ADDENDUM NUMBER #1

PROJECT	BIDS DUE
Charter Township of Garfield South Airport Road Force Main Replacement GFA Project No: 26273	Date: October 22, 2026 Time: 9:00 AM Location: Charter Township of Garfield 3848 Veterans Drive Traverse City, MI 49684

CHARTER TOWNSHIP OF GARFIELD SOUTH AIRPORT ROAD FORCE MAIN REPLACEMENT PLAN AND PROFILE SHEET - ALTERNATE 'A' SECTION 14, T.27 N., R.11 W. GARFIELD TOWNSHIP, GRAND TRAVERSE COUNTY, MICHIGAN

26273
C2.1A

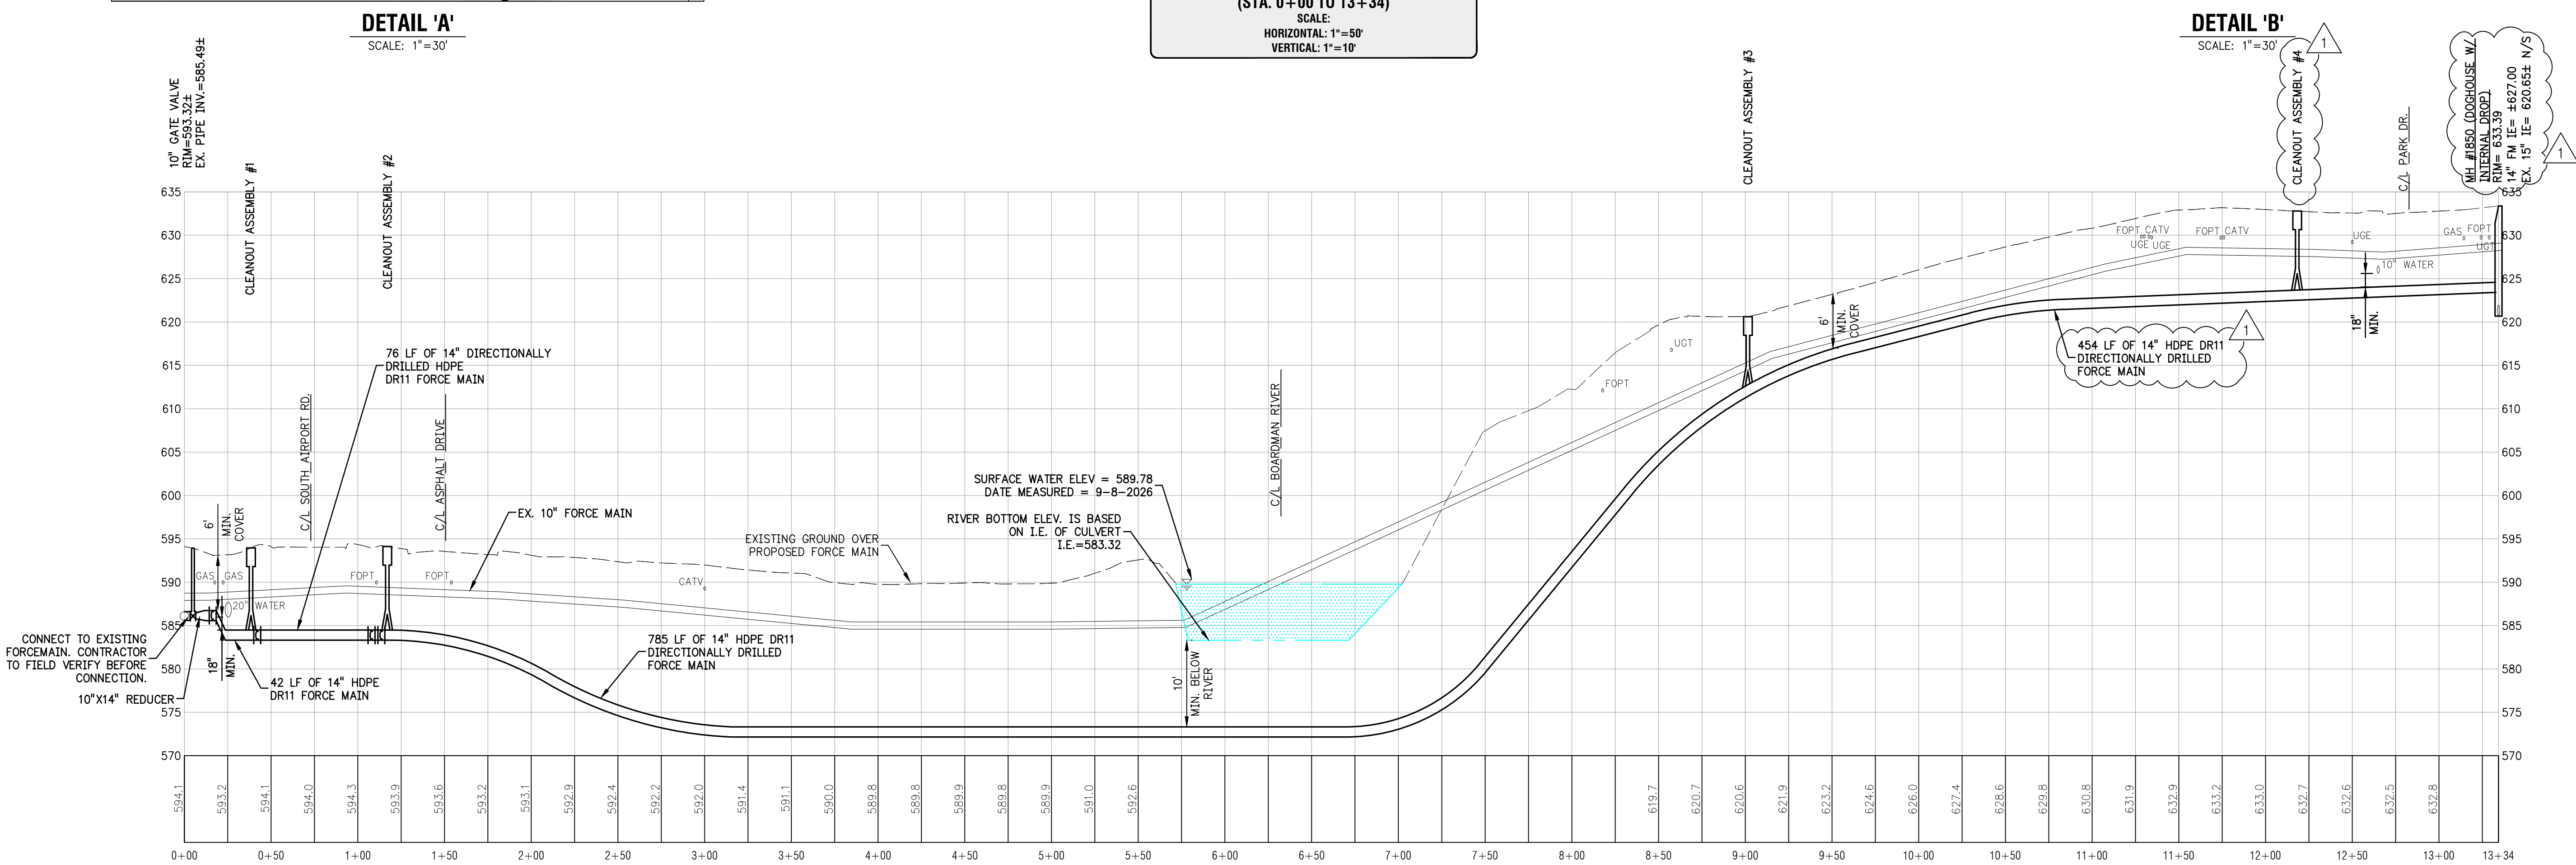
1. Sheet C2.1A included in this addendum shall be incorporated into the bid documents. This sheet has been added to the plan set to reflect an Alternate.
2. Sheet C3.1 shall be stricken in its entirety and shall be replaced with the attached and incorporated into the bid docs. The sheet has been modified to include additional details for the alternate and additional clarifications.
